Inver Grove Heights Planning Commission
Tuesday, June 4, 2024 at 7:00 PM
8150 Barbara Avenue, Inver Grove Heights, MN 55077

AGENDA

MEETING DATE:	June 4, 2024
CASE NO:	24-15V
APPLICANT:	Toll Company
PROPERTY OWNER:	Stag Industrial Holdings, LLC
REQUEST:	Variance
LOCATION:	8450 Courthouse Boulevard
COMPREHENSIVE PLAN:	Industrial Office Park
ZONING:	IOP, Industrial Office Park
STAFF CONTACT:	Allan Hunting, 651.450.2554

MEETING DATE:	June 4, 2024
CASE NO:	24-16PUD
APPLICANT:	InSite Development Services, LLC
PROPERTY OWNER:	Graceland IGH Holdings, LLC
REQUEST:	Planned Unit Development Amendment
LOCATION:	7761 Amana Trail
COMPREHENSIVE PLAN:	RC, Regional Commercial
ZONING:	PUD, Planned Unit Development
STAFF CONTACT:	Allan Hunting, 651.450.2554

EXTERIOR
ELEVATIONS

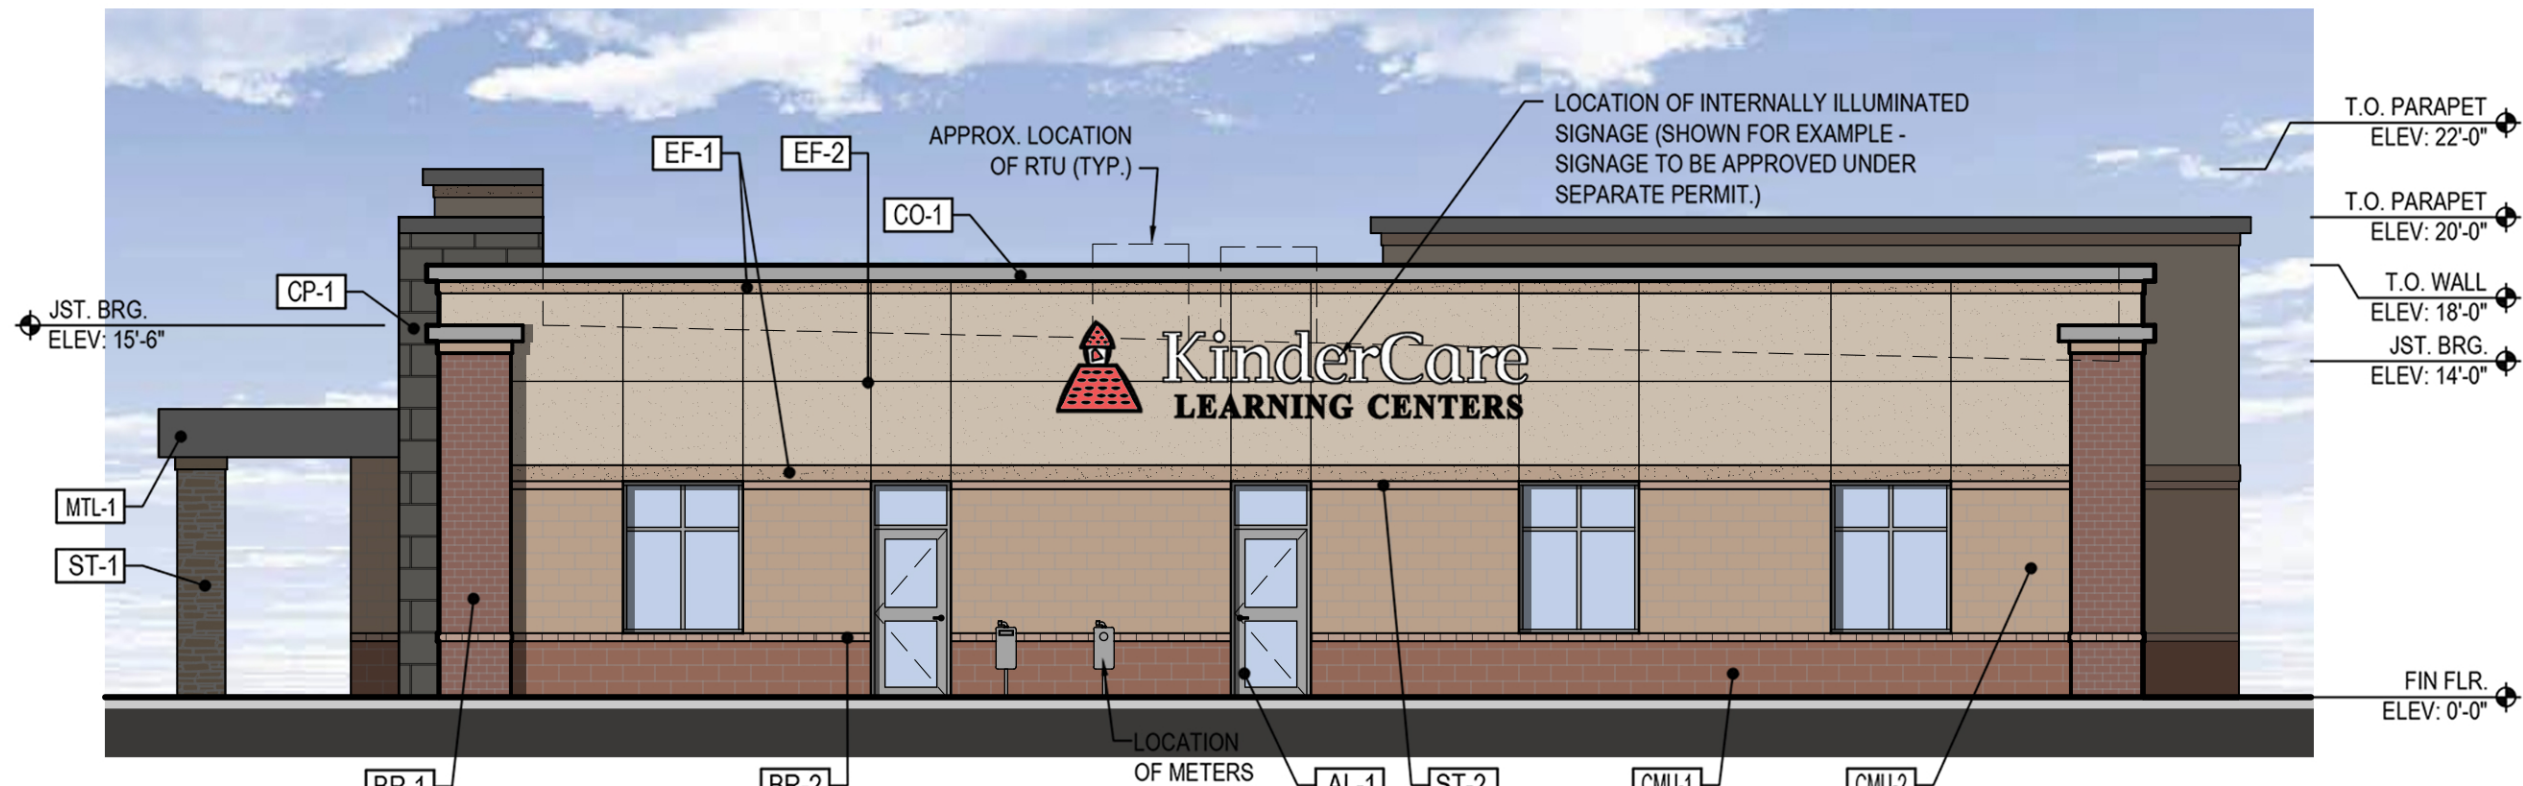
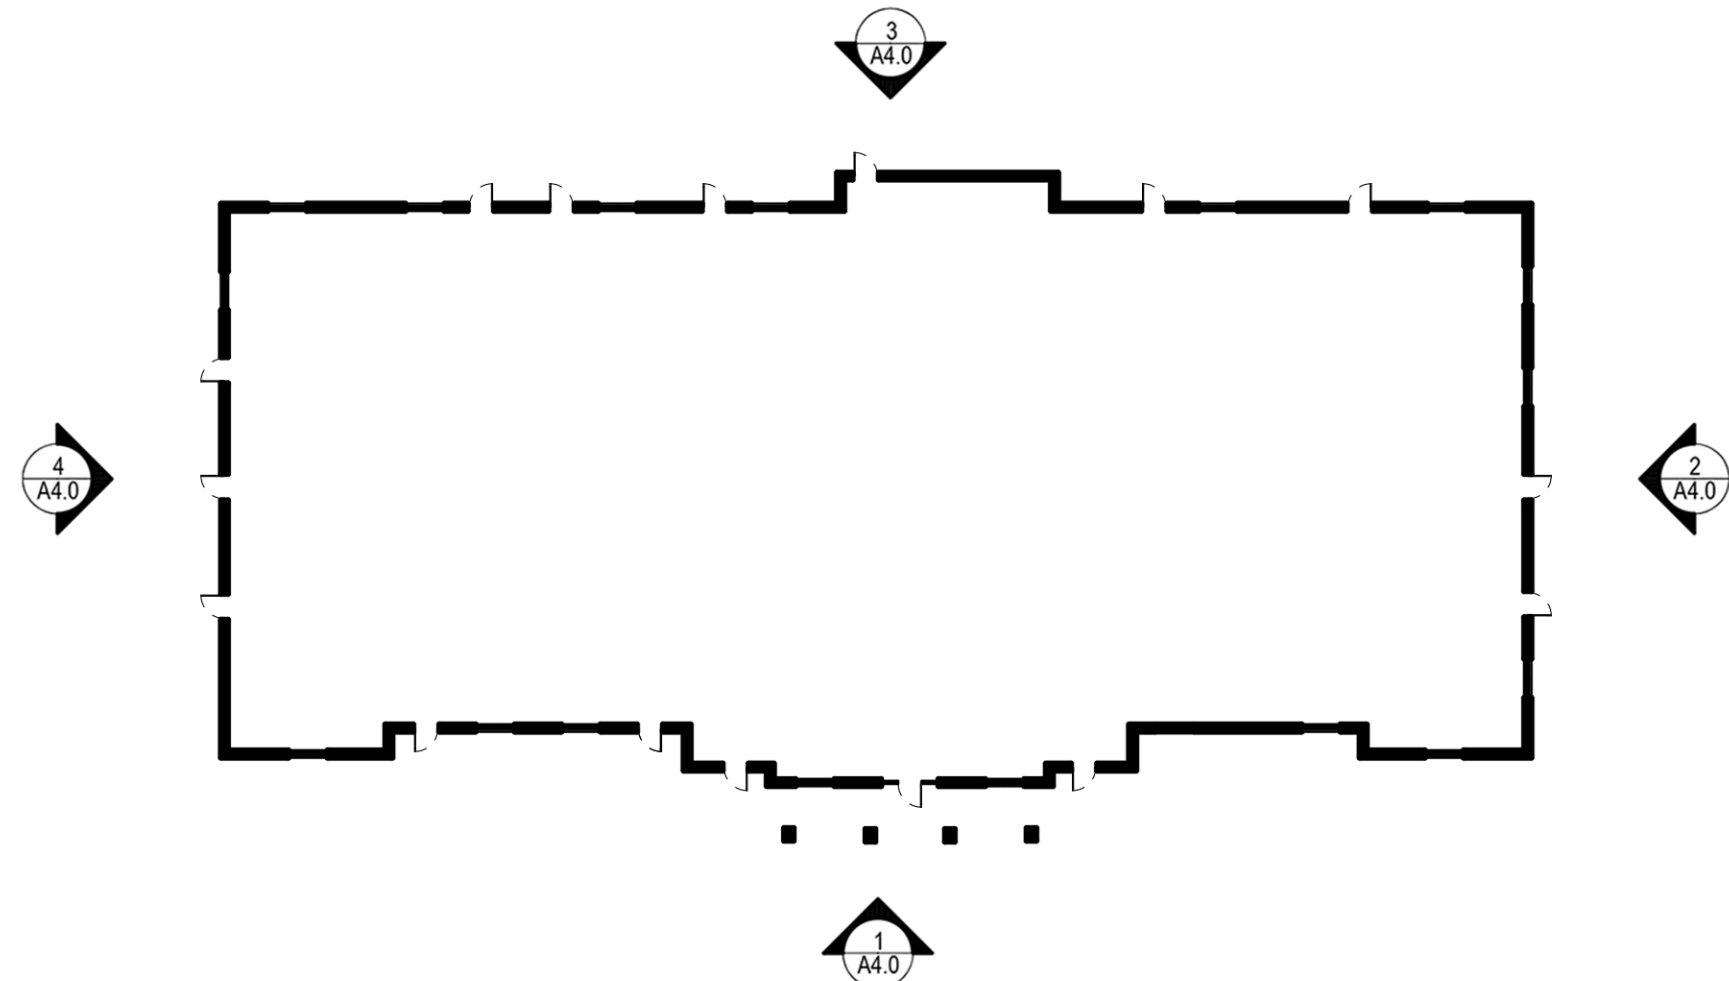
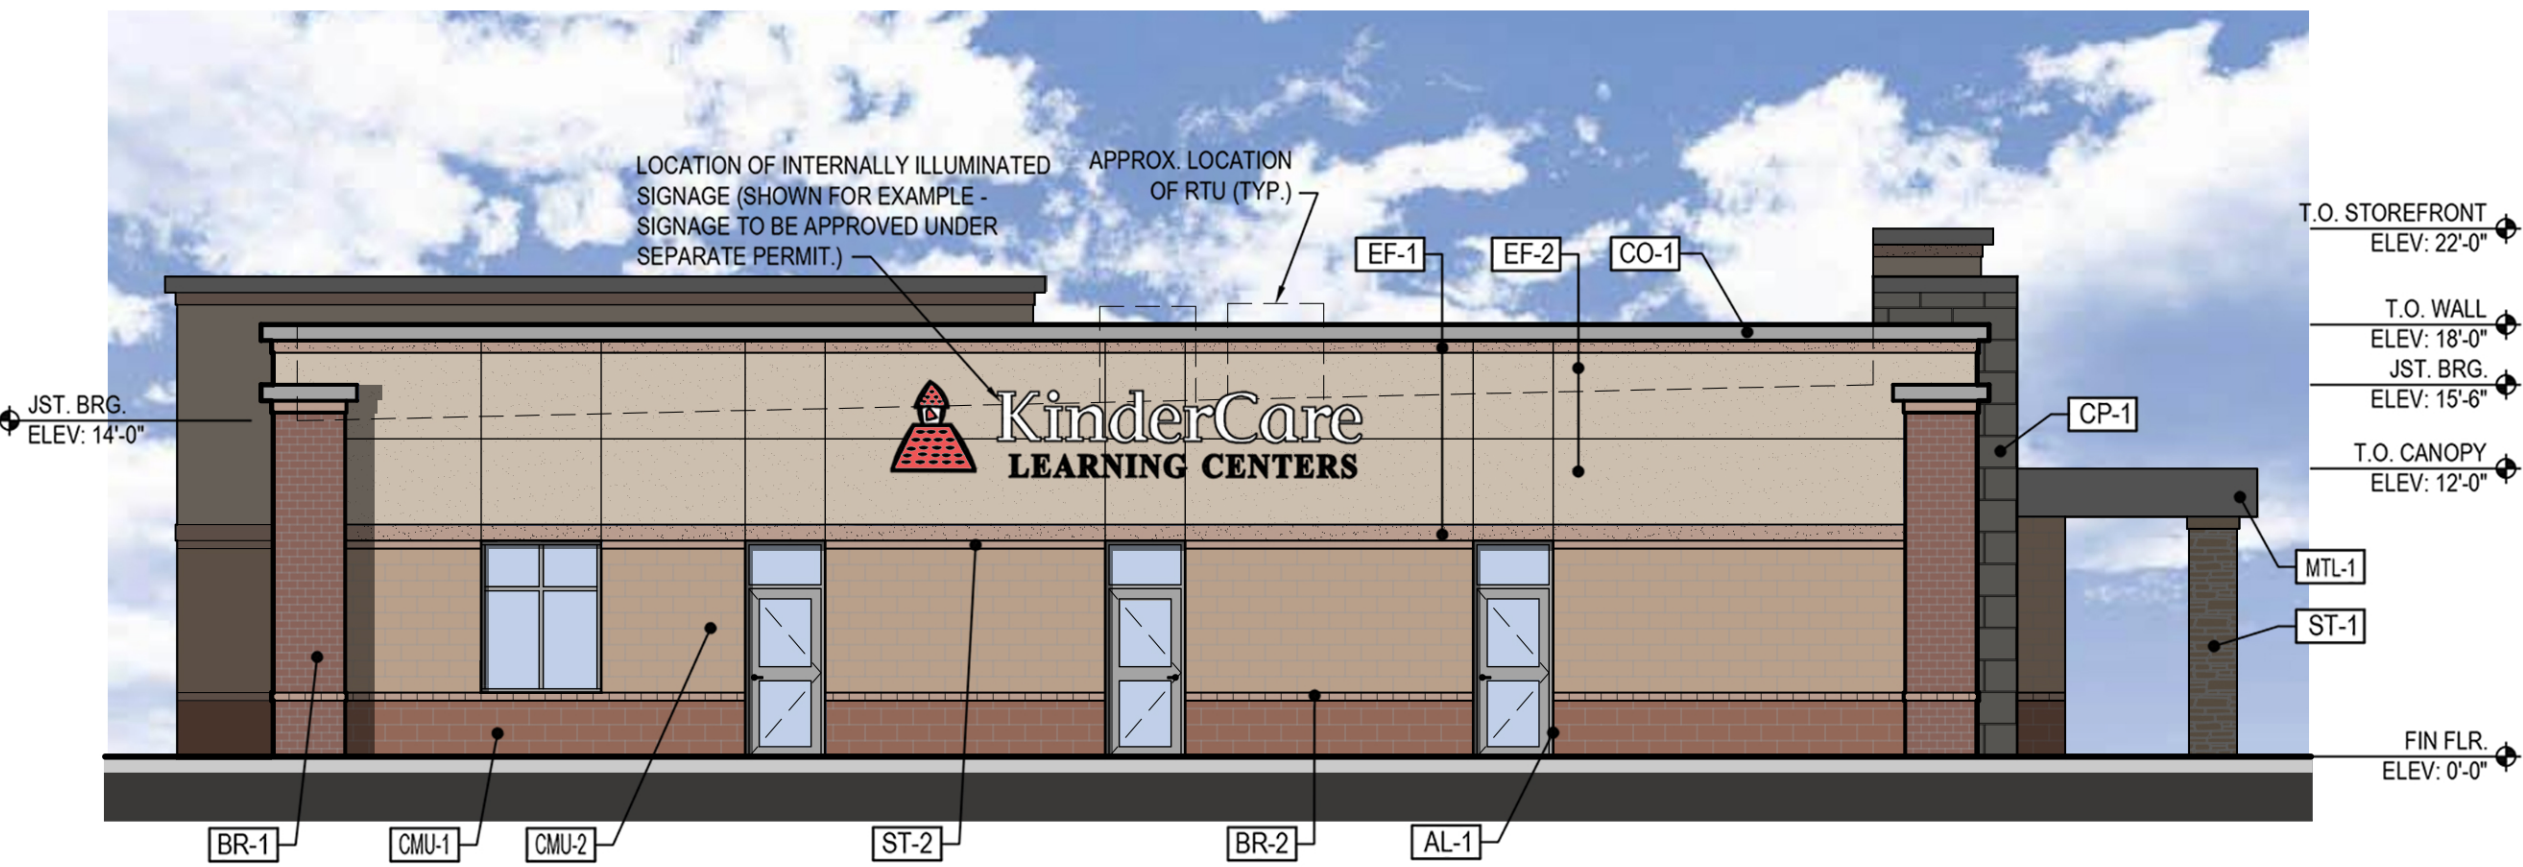
Exterior. The applicant is proposing the building exterior to match the design guidelines of the Argenta Hills PUD, which provides for a mix of brick, block, and smooth-faced surfaces.

Rooftop Equipment. The plans identify the approximate location of rooftop equipment but show it may extend above the top line of the building parapet. The City Code requires the equipment be substantially screened from view from a reasonable viewing perspective.

5. Any rooftop or ground mounted equipment shall be substantially screened from view as seen from a reasonable viewing perspective.
